Access Compliance Report

Public Rights-of-Way

(Curb Ramps)

Intersection ID: 10640	Main Street: MARTIN_ST	Cross Street: WAKE_ST	Location: E
ADA ID: 113CCFB09F1D	Ramp Type: Perp	Initial Pass/Fail: Fail	Overall Compliance: No
Severity Score: 33.75			
Codes/Mitigation Info/Possible Solution		Field Measurements/Component Compliance

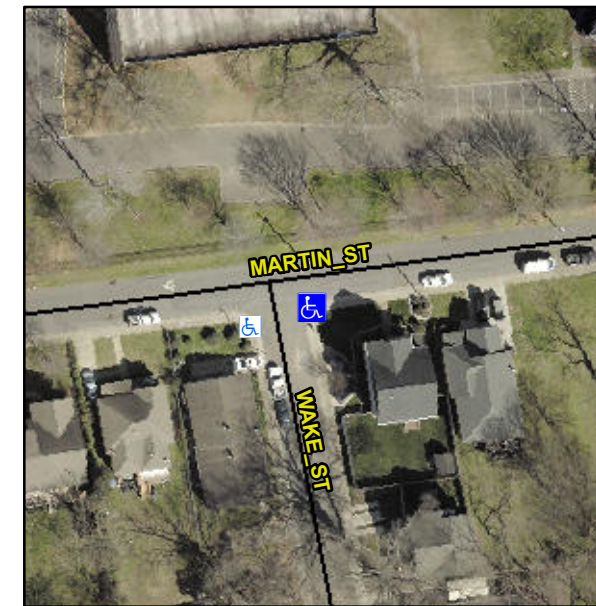
Not Found, R304.5.1, R304.5.3

Compliance	Description	Data	Compliance	Description	Data
N/A	Ramp Length (in)	48.0	Yes	Ramp Slope (%)	5.5
No	Ramp Width (in)	39.0	No	Ramp XSlope (%)	10.1
N/A	Flare Type LT	N/A	N/A	Flare Type RT	N/A
N/A	Flare Slope LT (%)	N/A	N/A	Flare Slope RT (%)	N/A
N/A	Flare Traversable LT?	N/A	N/A	Flare Traversable RT?	N/A
N/A	Landing Length (in)	N/A	N/A	DWS Provided?	N/A
N/A	Landing Width (in)	N/A	N/A	DWS Contrast?	N/A
N/A	Landing Slope (%)	N/A	N/A	DWS Length (in)	N/A
N/A	Landing X Slope (%)	N/A	N/A	DWS Full Width?	N/A
N/A	Landing Curb? (Y/N)	N/A	N/A	DWS Offset (in)	N/A
N/A	Shared Landing?	N/A			
N/A	Gutter Ponding?	N/A	N/A	Gutter Slope (%)	N/A
N/A	Gutter Lip Ht (in)	0.5	N/A	Gutter X Slope (%)	N/A
N/A	Painted X Walk1?	No	N/A	Painted X Walk2?	N/A
	X Walk 1 Direction	To W		X Walk 2 Direction	N/A
N/A	X Walk 1 Width (in)	N/A	N/A	X Walk 2 Width (in)	N/A
	X Walk 1 Slope (%)	4.4		X Walk 2 Slope (%)	N/A
	X Walk 1 X Slope (%)	12.6		X Walk 2 X Slope (%)	N/A

N/A	Ramp inside XWalk1?	N/A	N/A	Ramp inside XWalk2?	N/A
	Road Slope (%)	N/A	N/A	Clear Space?	N/A
	Road X Slope (%)	N/A	N/A	Clear Space to XWalk (in)	N/A
N/A	Any Obstructions?	N/A	N/A	Storm Grate/Utility Hazard?	N/A
	Obstruction Type			Storm Grate/Utility Type	
		N/A			N/A
			Yes	Surface Condition? (G/P)	Good

Remove & Replace Entire Ramp.
